RENESAS TECHNICAL UPDATE

Product Category	MPU/MCU		Document No.	TN-RIS-A0001B/E	Rev.	2.00
Title	Note about the interruption during the transition to low power modes		Information Category	Technical Notification		
Applicable Product	Renesas R9A02G021	Lot No.	Reference Document	Renesas R9A02G021 User's Manual: Hardware R01UH1036EJ0110 Rev.1.10		
		All

Corrections are made to the figures and tables in the user's manual hardware as shown in 1 and 2 below.
If the software meets the applicable condition listed in 3 below, you may not be able to enter the intended low power mode and transit to unintended states described in 3 below.
If the unintended states described in the following 3 notes cannot be tolerated, use the following 4 workaround.

Figure 10.1 Low power mode transitions

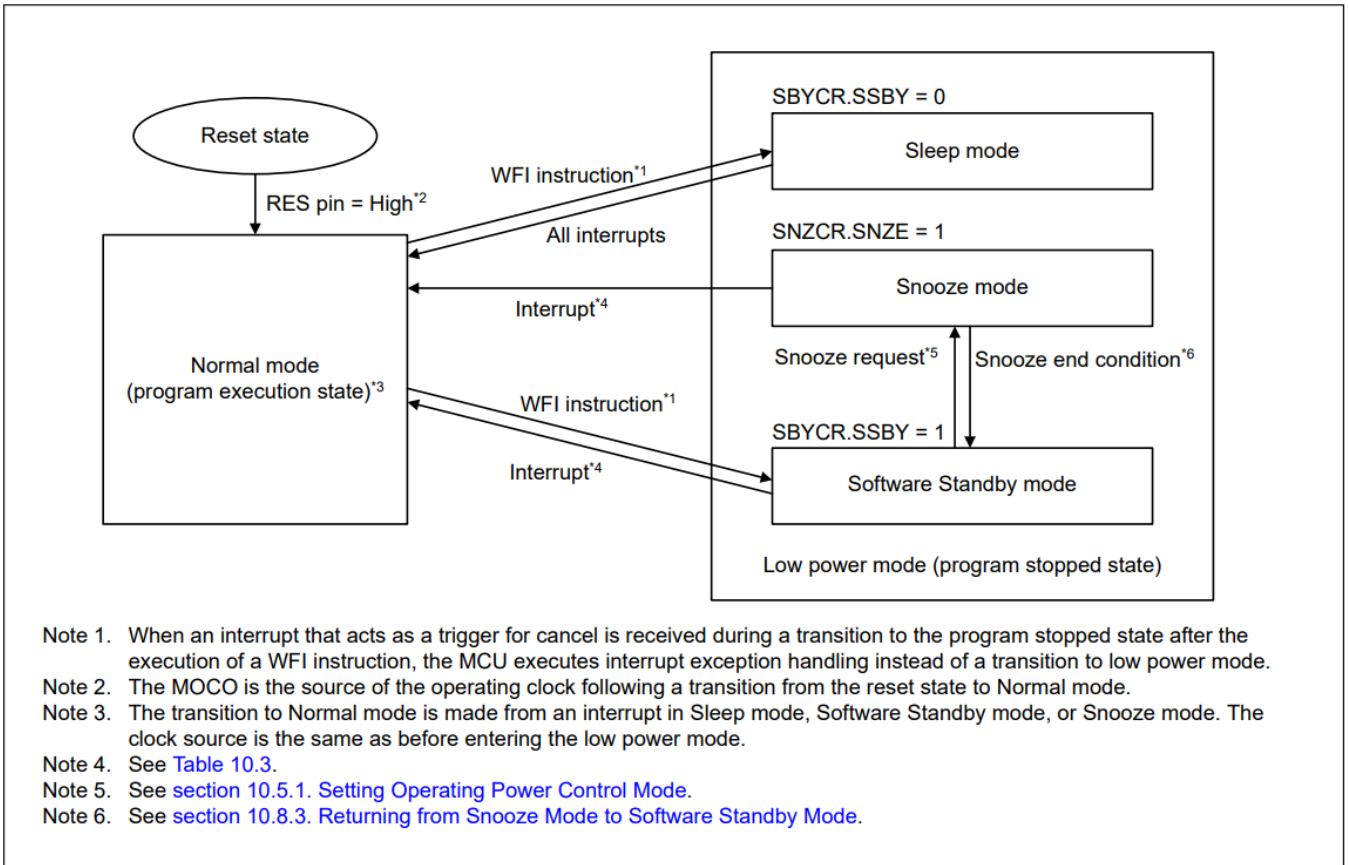
Fig10.1 is corrected as follows. Note 1 sentence is corrected and note 7 is added.

Note 1. When an interrupt that acts as a trigger for cancel is received during a transition to the program stopped state after the execution of a WFI instruction, the MCU executes interrupt exception handling instead of a transition to low power mode.

Note 1. When an interrupt that acts as a trigger for **cancellation of the Sleep mode state** is received during a transition to the **Sleep mode**, the MCU does not transit to Software standby mode state but go back to after the execution of a WFI instruction, the MCU executes interrupt exception handling instead of a transition to low power mode.

Note. 7 When an interrupt acts as a trigger for cancellation of the Sleep mode state is received during a transition to the **Software Standby mode state**, the MCU does not transit to Software Standby mode state but go back to Normal mode state.
